**PREVOST**

SAFETY RECALL

SR14-02

DATE :	FEBRUARY 2014	SECTION :	23 - Accessories
SUBJECT:	LOWER WINDSHIELD WIPER MOTOR INSPECTION

FIGURE 2: WIPER MOTOR WHICH MUST BE REPLACED. THE LETTERS "SWF" ARE STAMPER ON THE GEARBOX CASING.

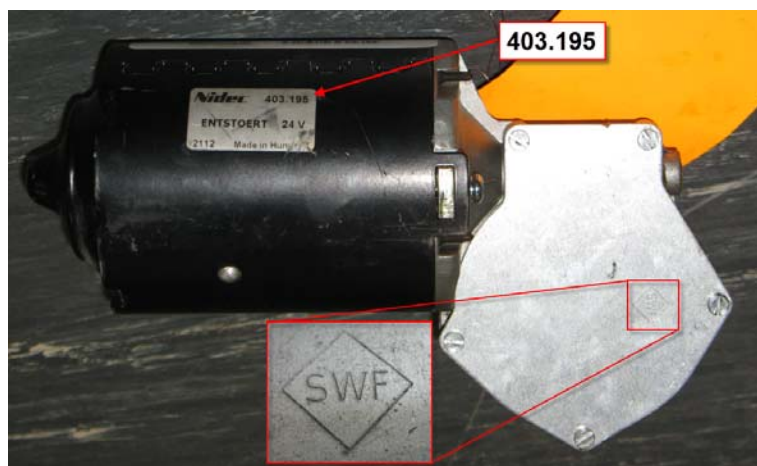
4. A wiper motor having the letters SWF stamped on the gearbox casing must be replaced. This wiper motor has also a label on which is printed the number 403 195. Proceed to the replacement of the wiper motor as described in Part 2 if the letters SWF are stamped on the gearbox casing

FIGURE 3

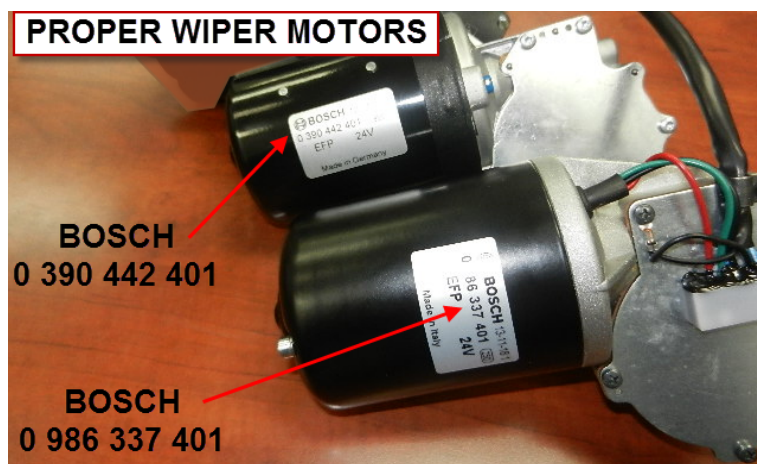
5. Proper wiper motor are identified Bosch #0 390 442 401 or #0 986 337 401. These Bosch wiper motors (Prevost part number 800328 and 800380) **do not** have to be replaced. If the wiper motor installed in your vehicle is one of these Bosch motors, no other verifications are required. This completes the campaign.
